KAWARTHA PINE RIDGE DISTRICT SCHOOL BOARD
PUR24-100-ITT
Murray Centennial Public School Addition

ADDENDUM NO. 3

Add (1): Architectural Addendum No. 2, Prepared by Moffet and Duncan Architects Inc. (34 Pages)

PARTIAL FLOOR PLAN - DEMO PHASE-1
1:75

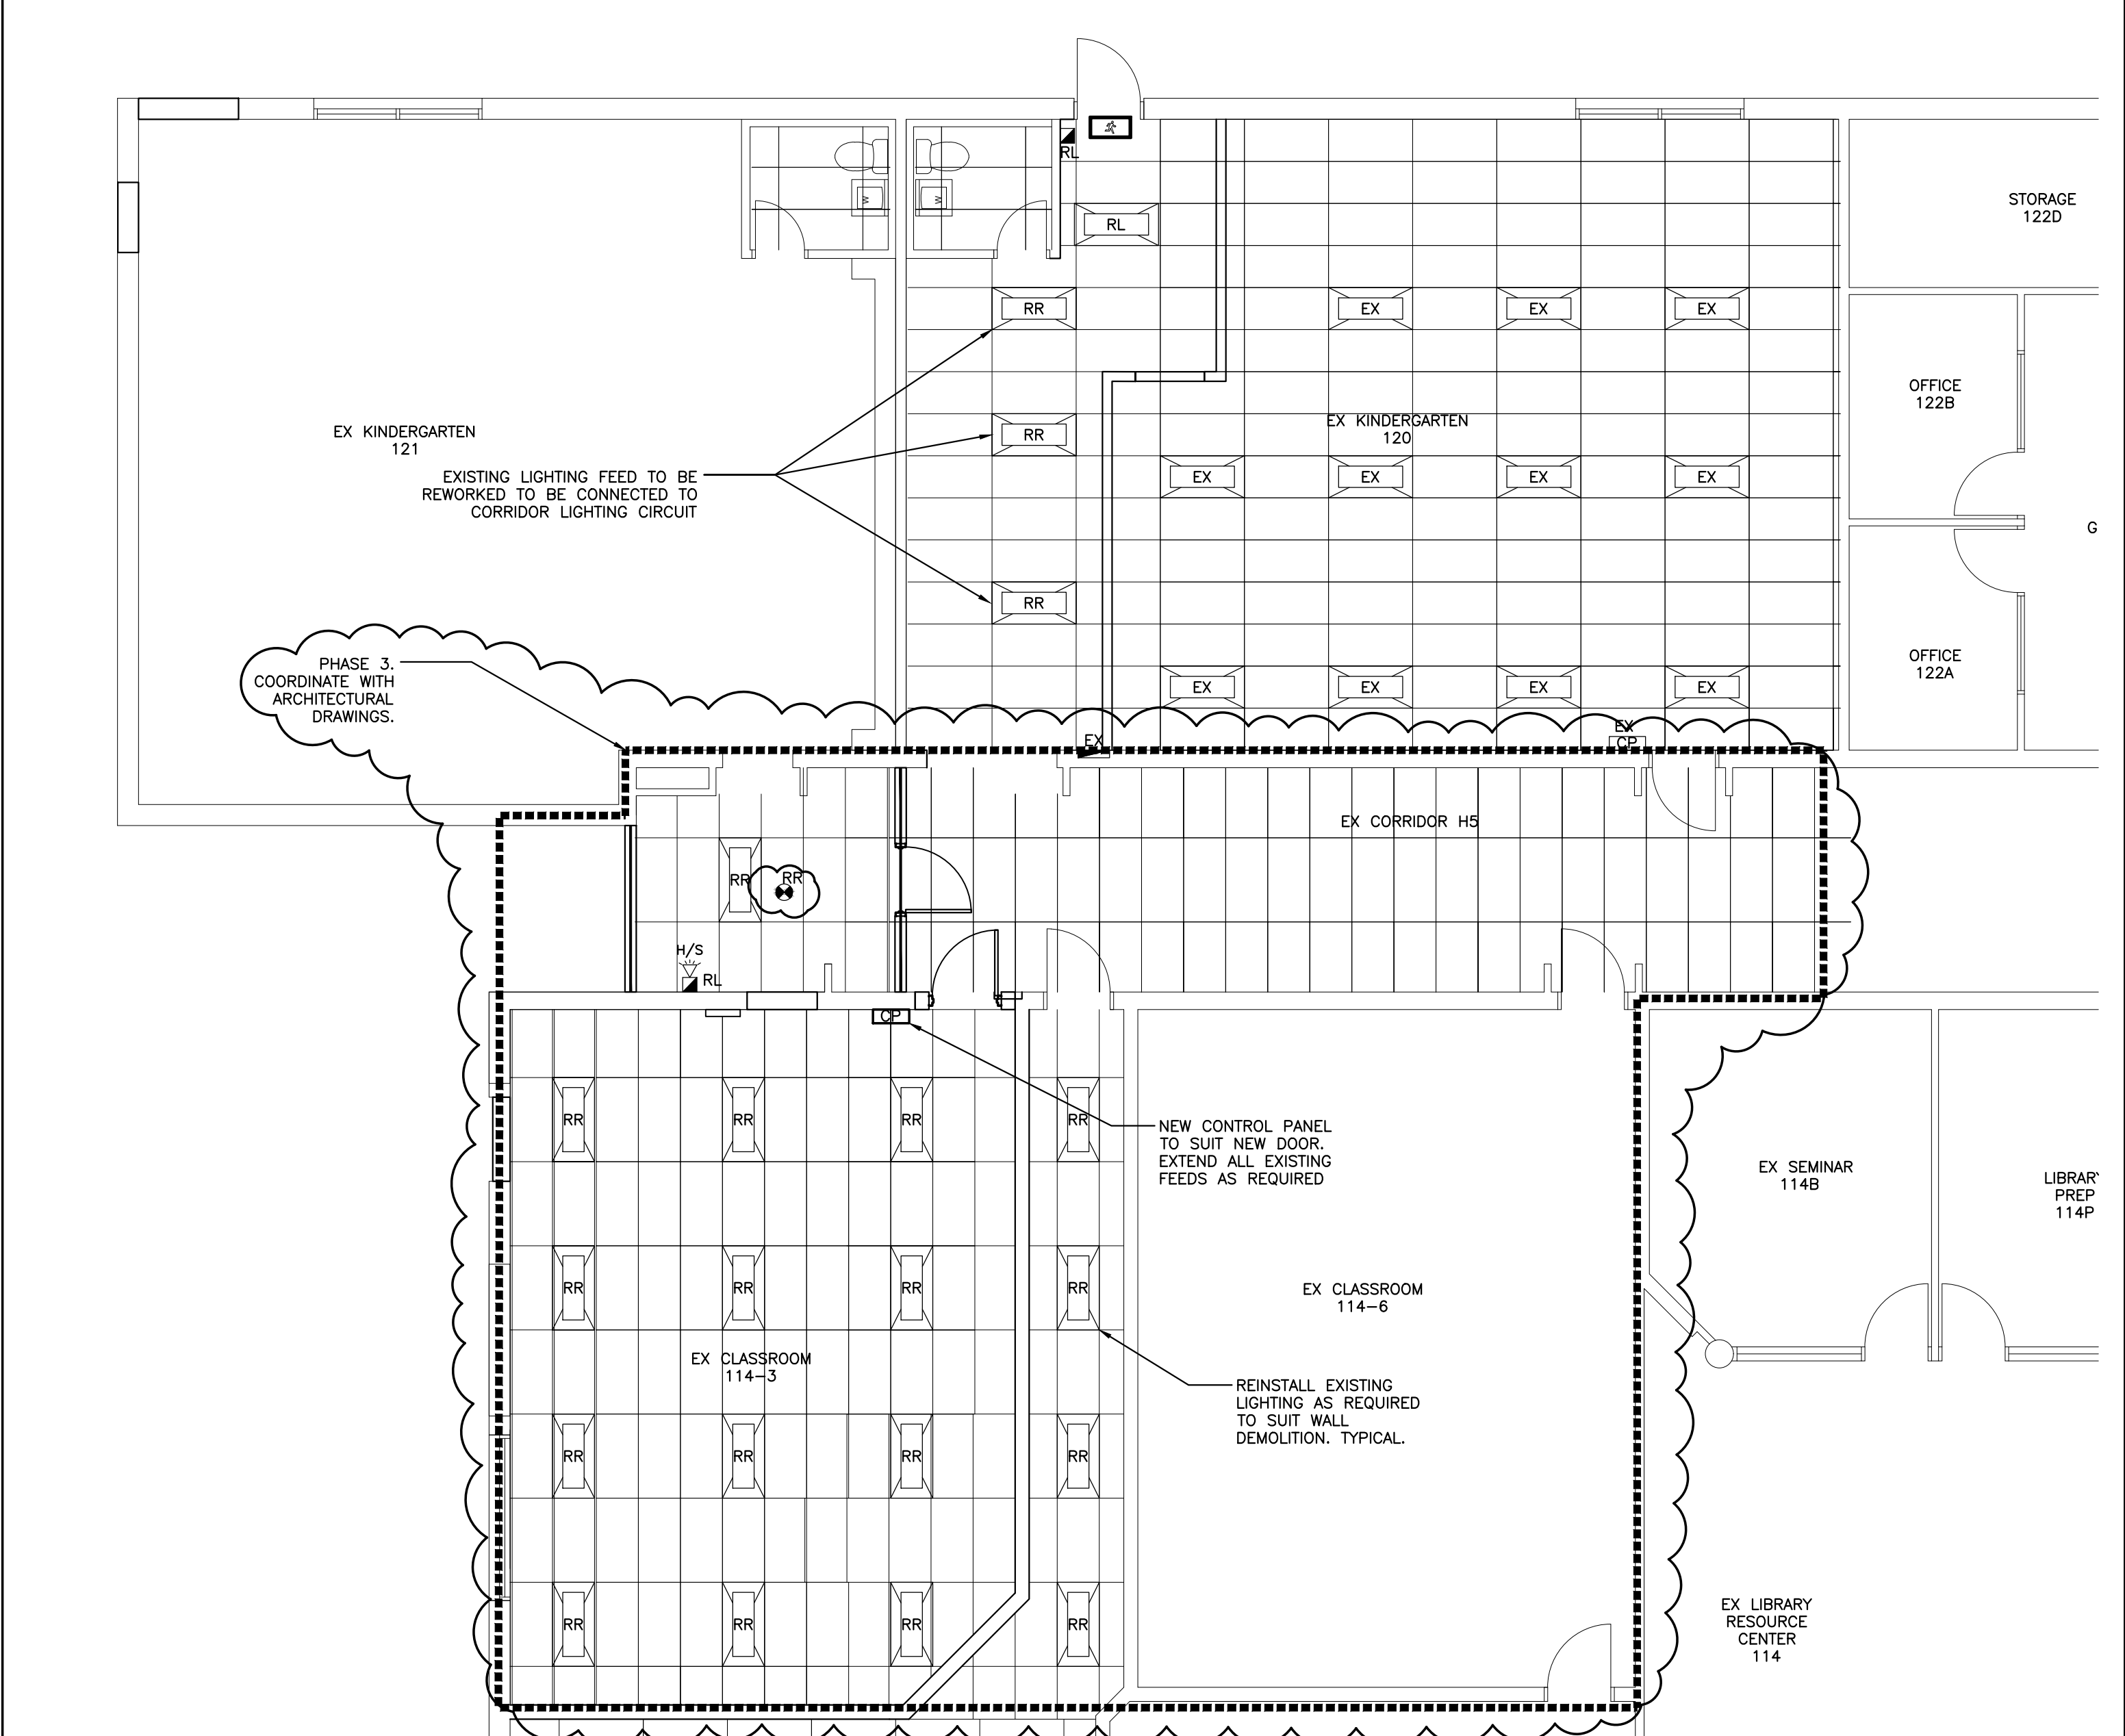
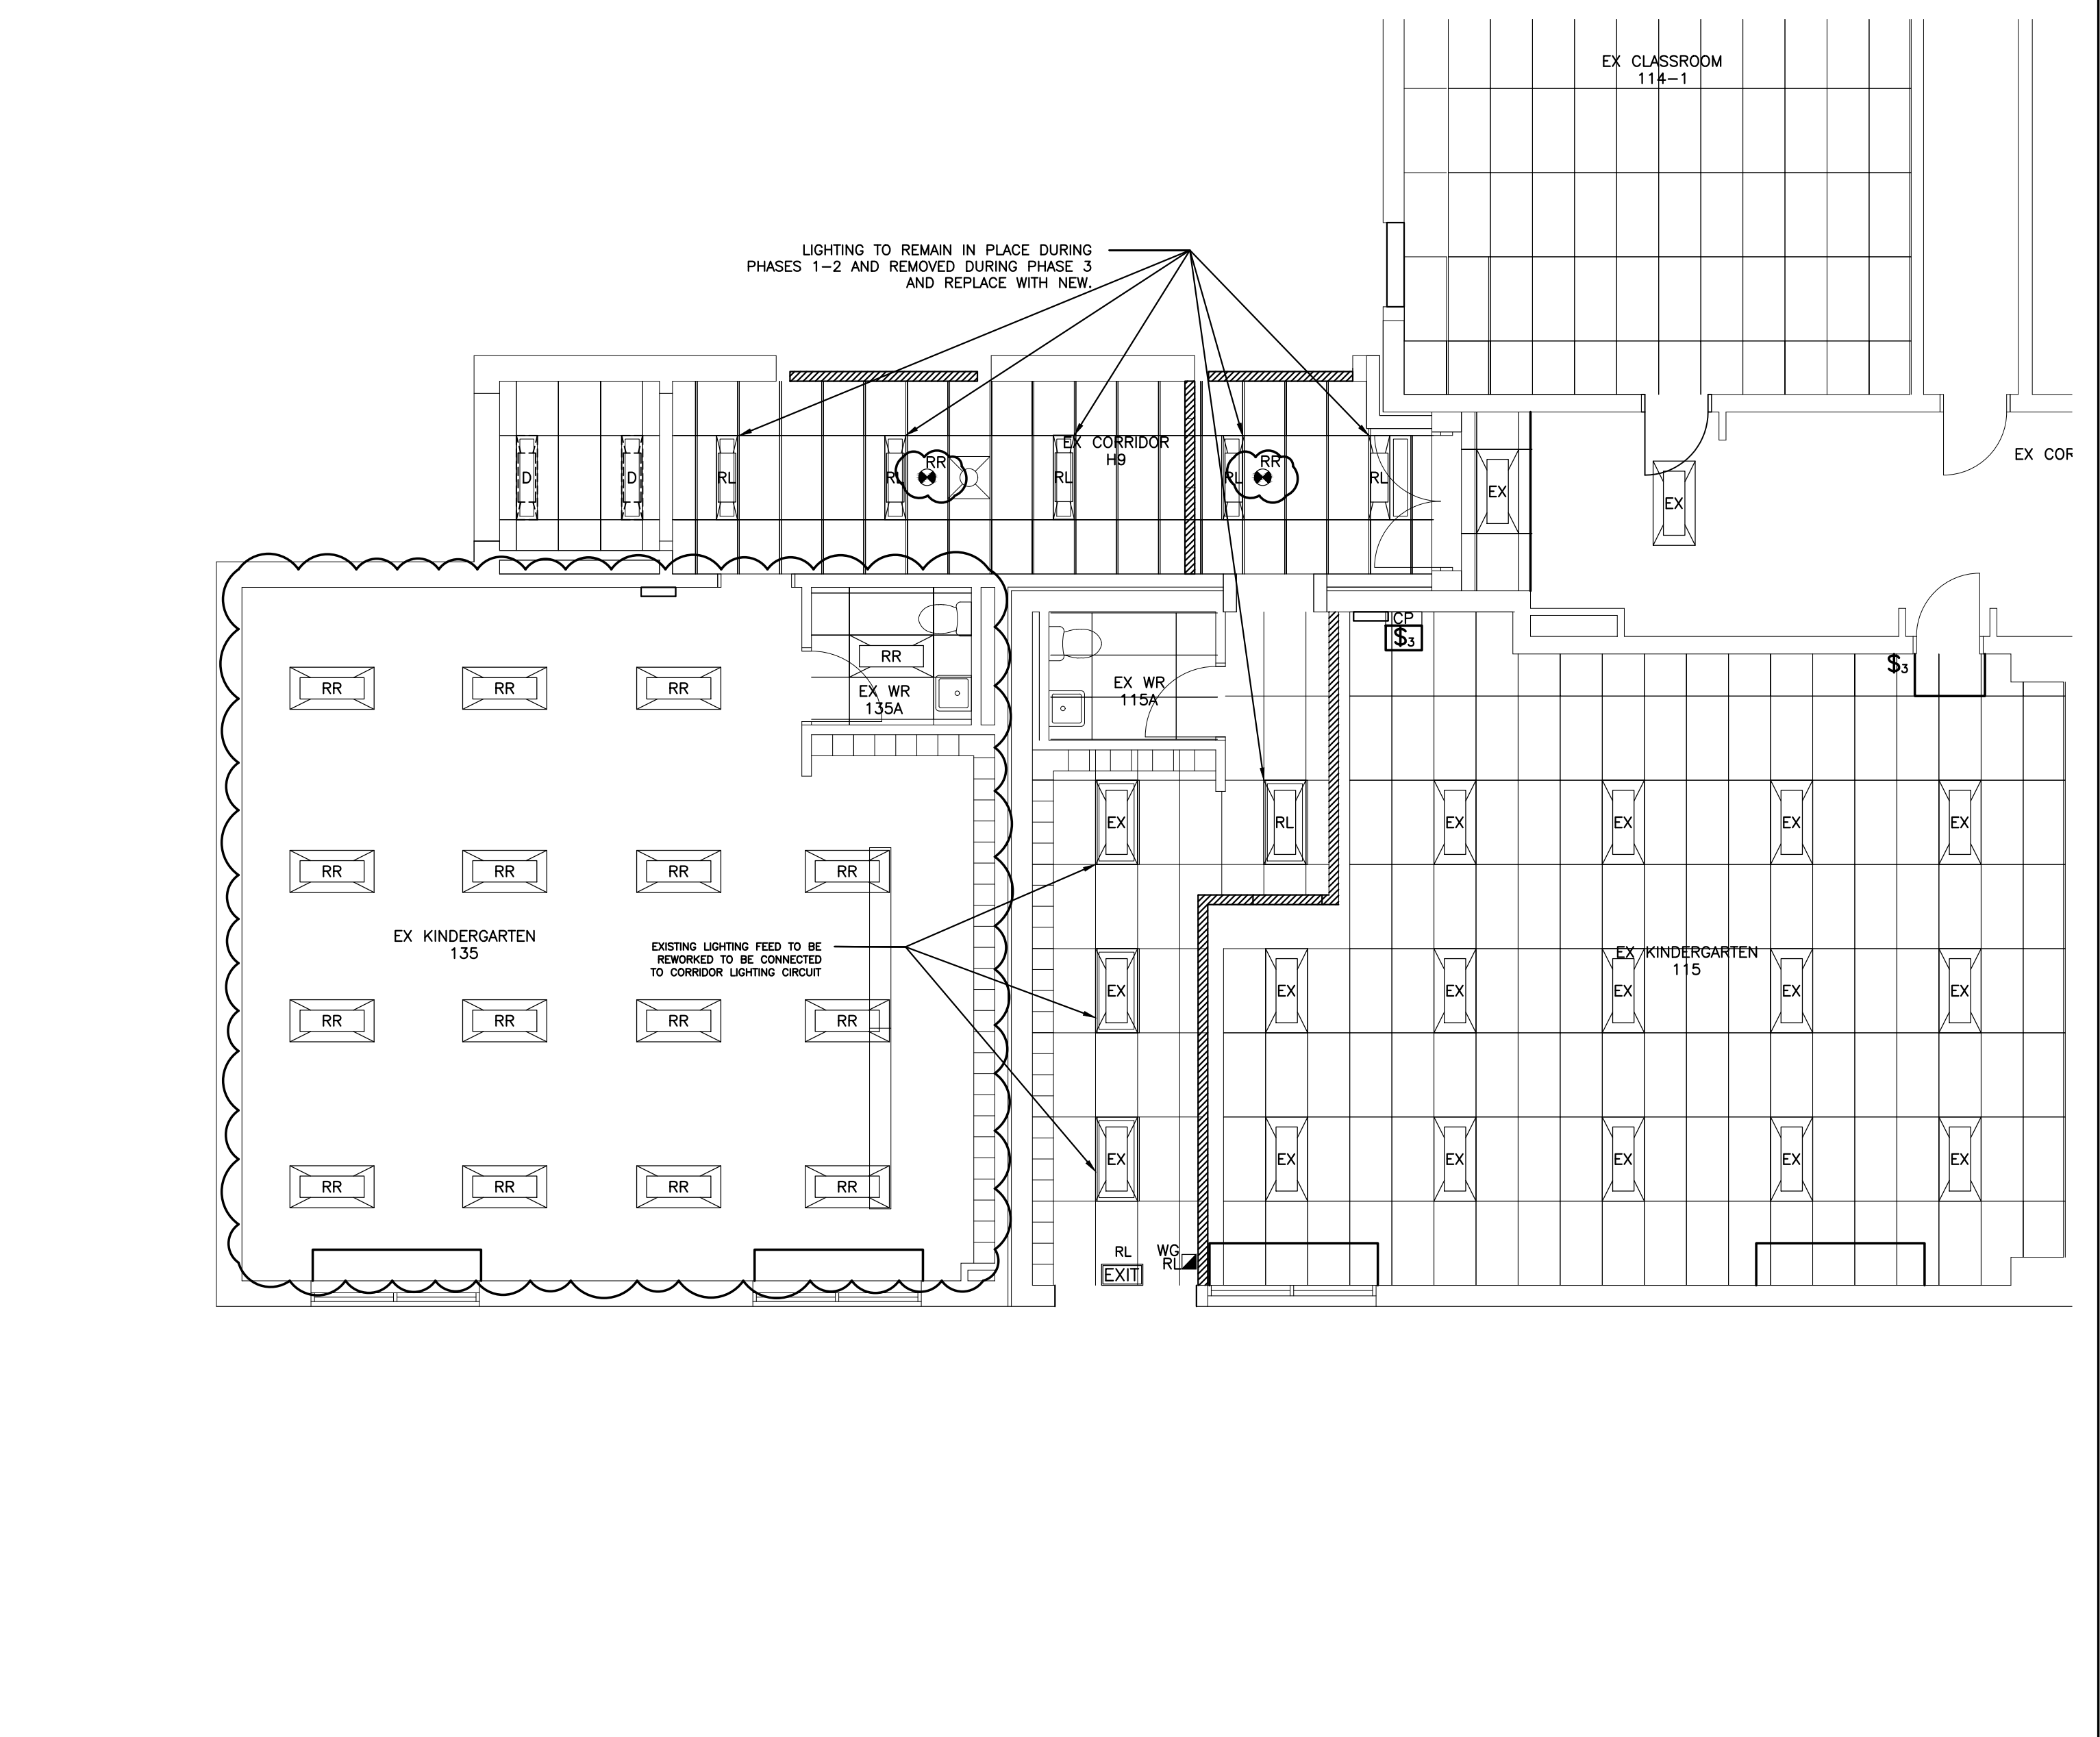
- .1 Refer to revised drawing. Work for certain areas shall be undertaken under Phase 3.
- .2 Disconnect and remove all lighting in Classroom 135 and retain for reinstallation.

SEWAGE SYSTEM PROPERTY PLAN

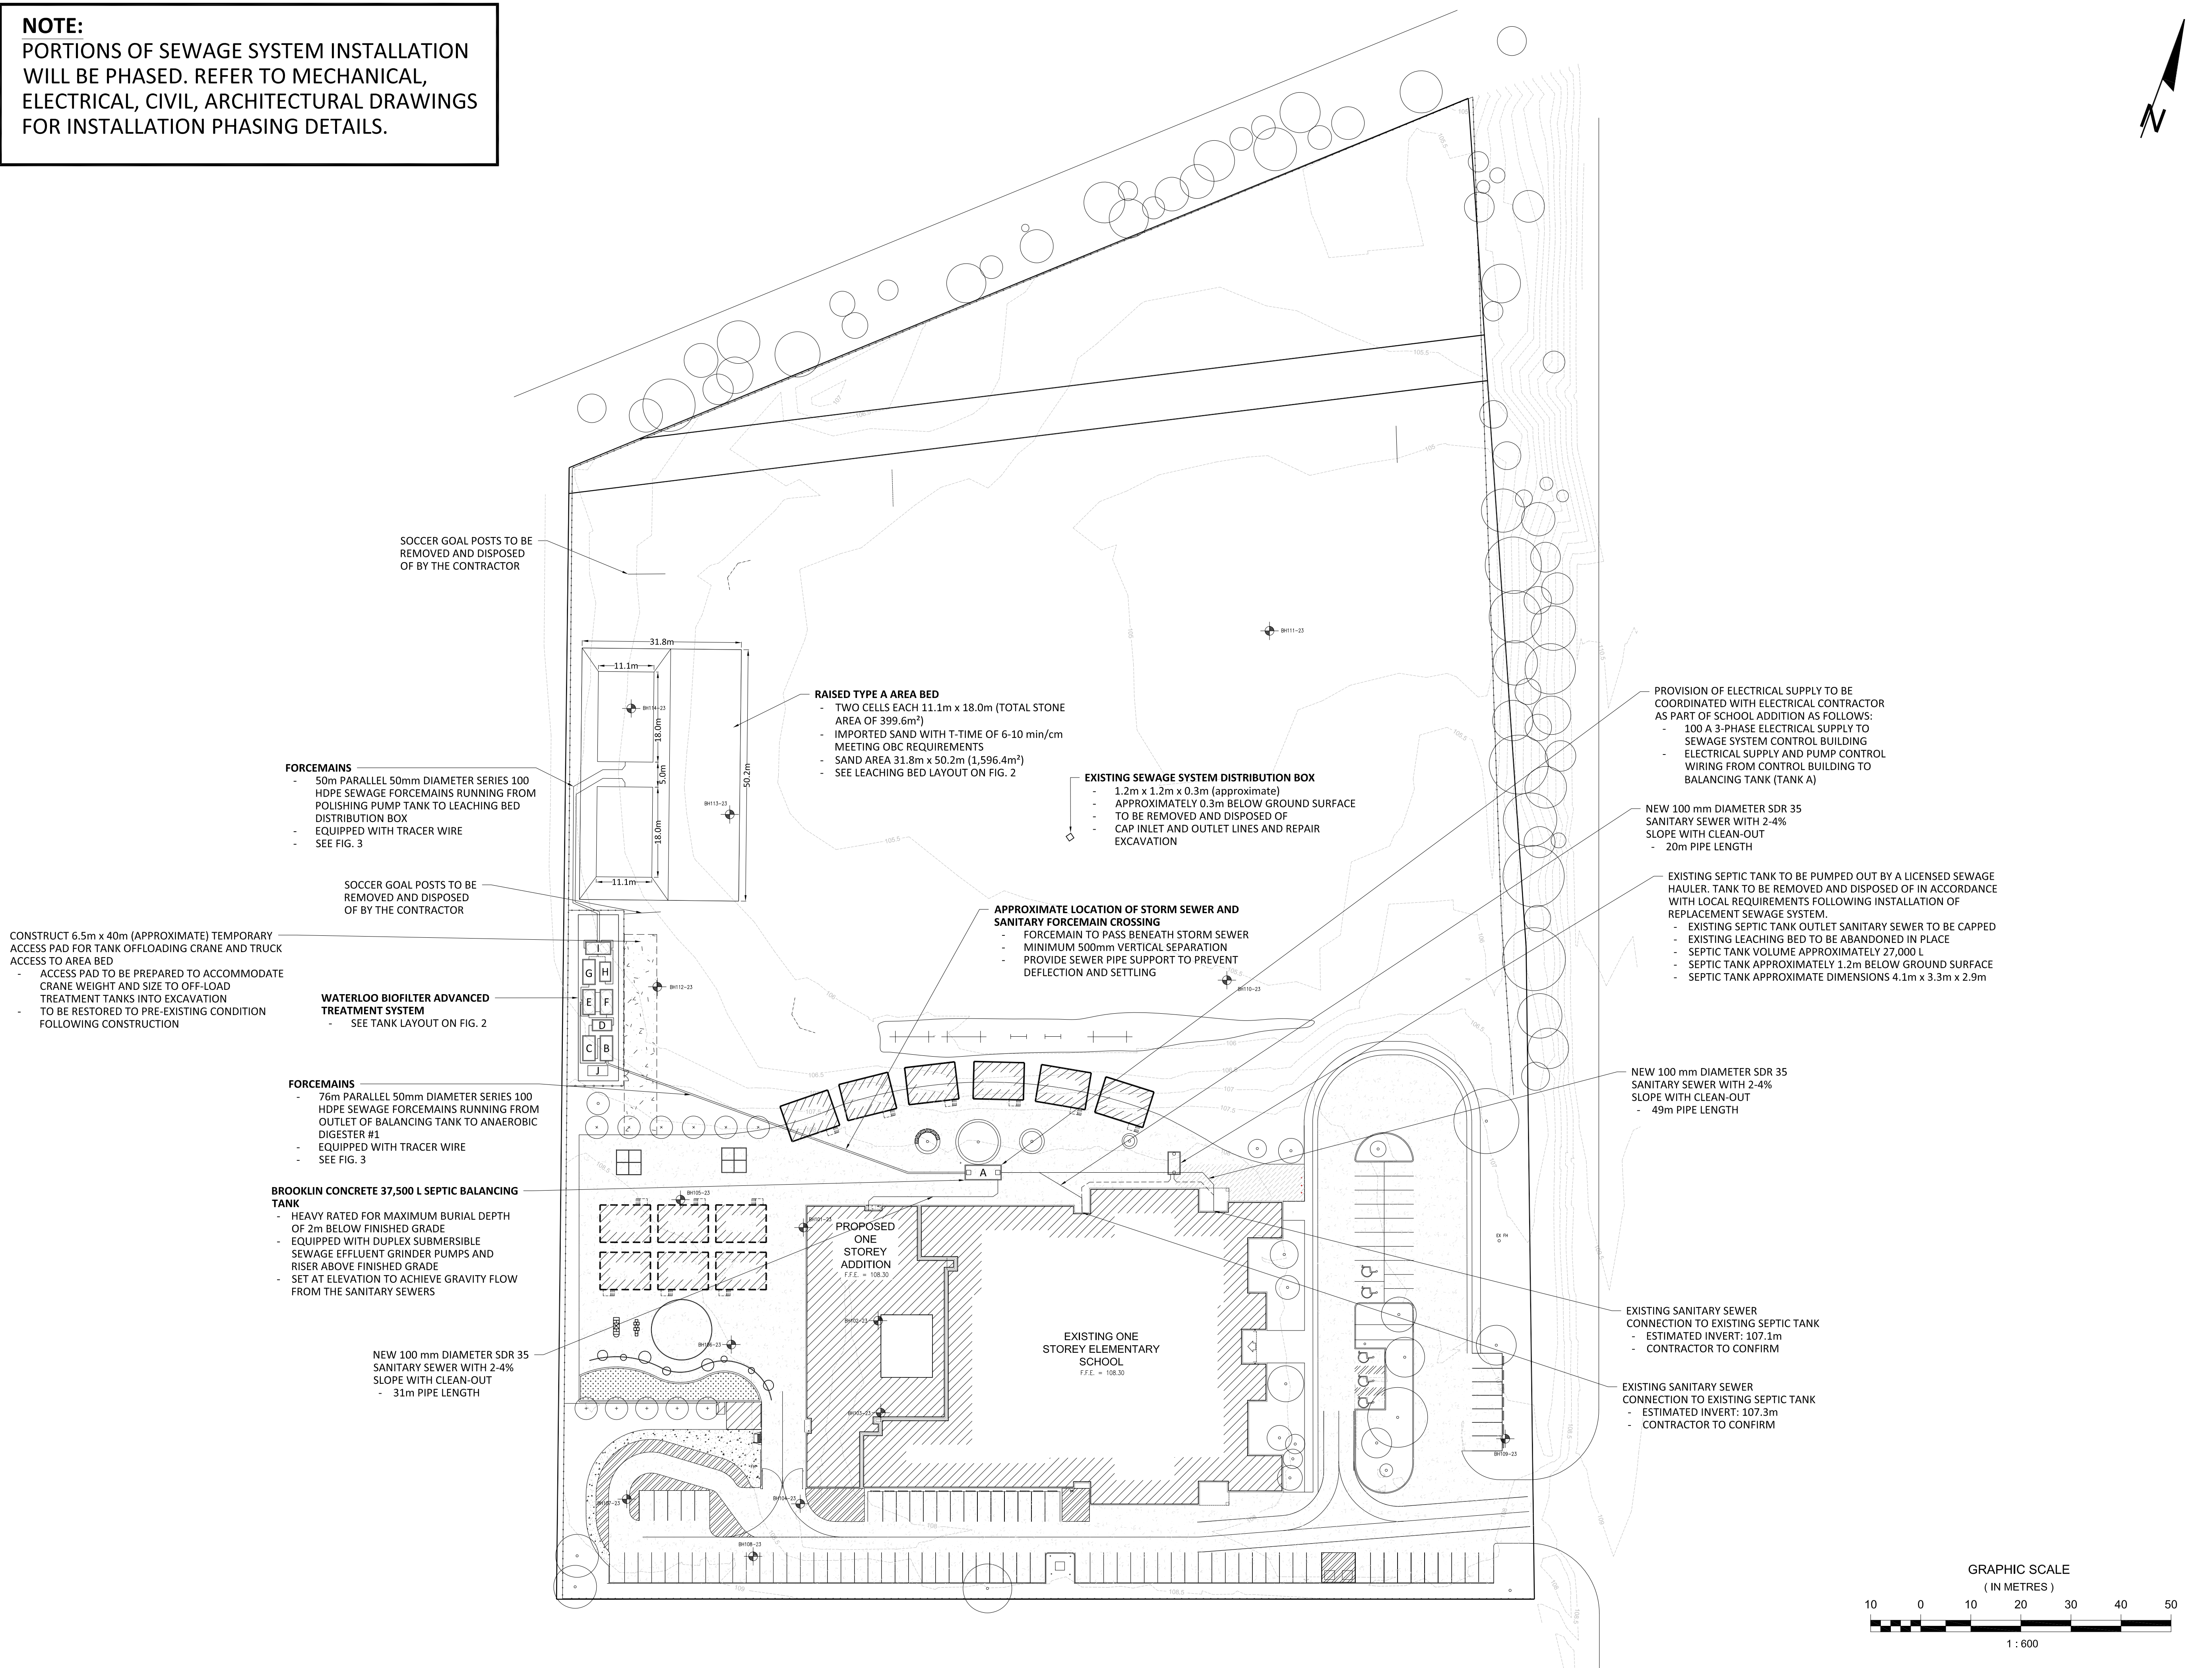
Figure	Edit Description
Figure 1: Sewage System Property Plan	Existing septic tank dimension, volume, and depth below ground surface added to drawing.
	Existing sewage system distribution box location added to drawing with approximate dimensions and requirement for removal.
